Spike Bracelet Controls

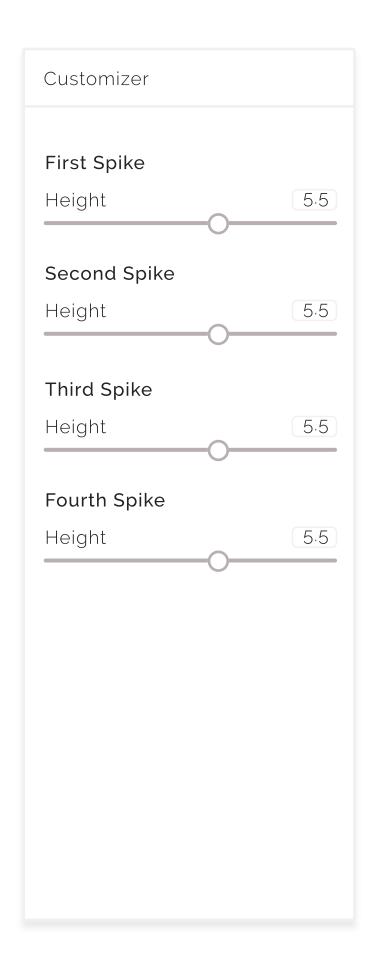
Make Spike(n) Top and Spike(n) Bottom continous. Slider value of .5 is flat. 0 and 1 put spikes at maximum height in either direction.

Opening on the bracelet also needs to be made bigger. Talk to me when you get to this one

Default slider values on base model to:

- .7
- .3
- .85
- .25
